Amendments

GRANARY DEVELOPMENTS

APPROVED DESIGN

CURRENT DESIGN

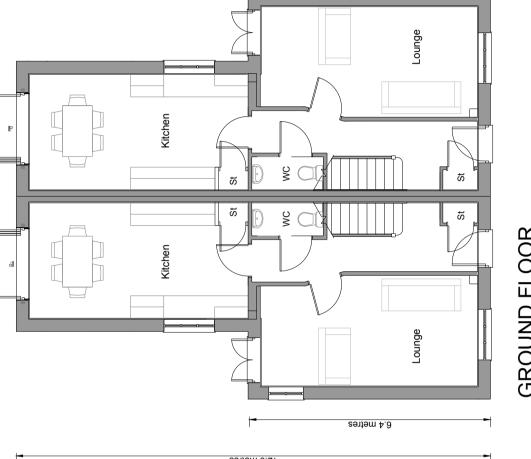
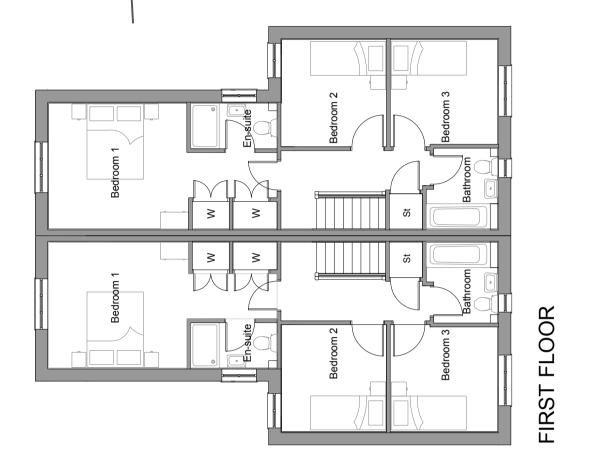
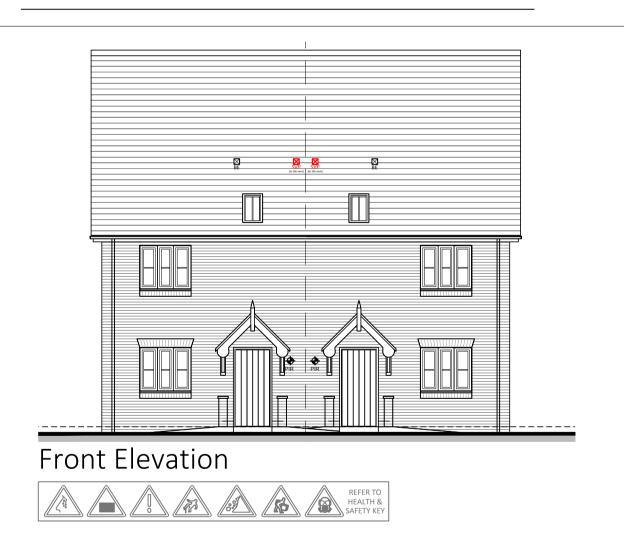
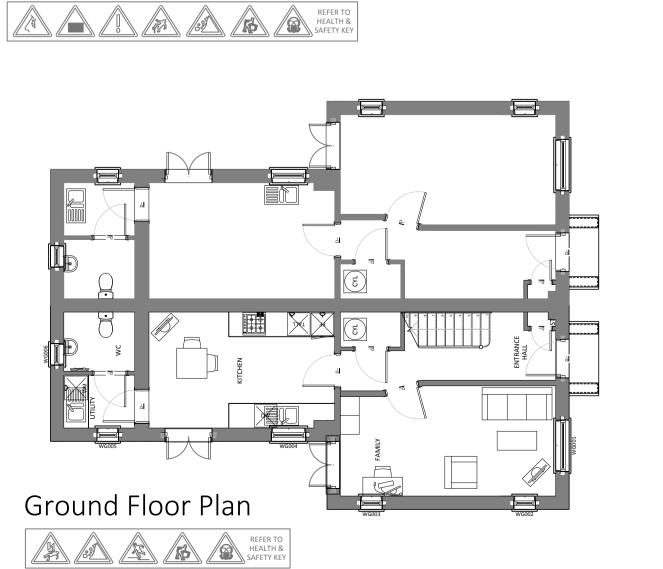
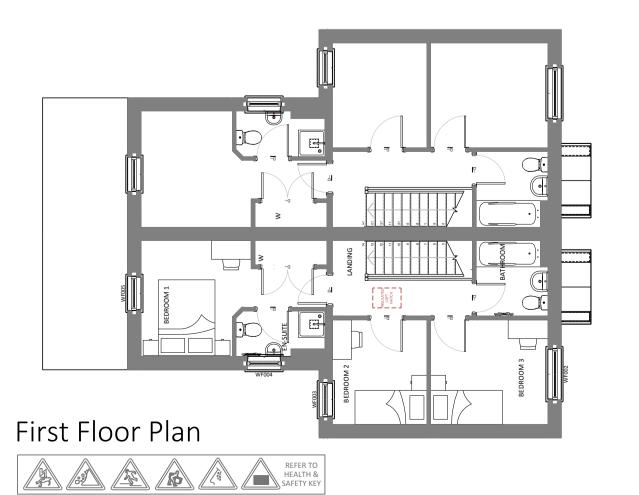
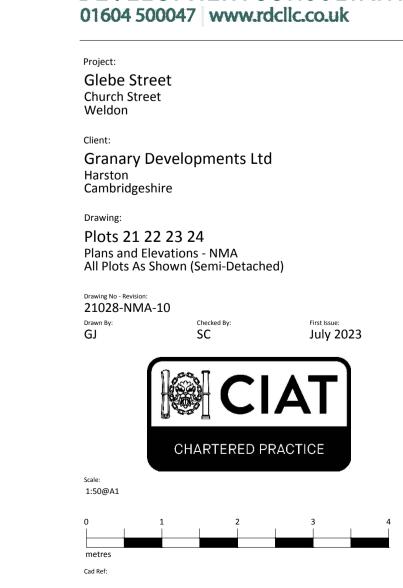
Chimney and fire place removed.

Eaves and verge changed

Window head and cill design changed.

Porch design changed.

GF layout changed - rear extended with the addition of a utility and downstairs WC.

Side window added to lounge.
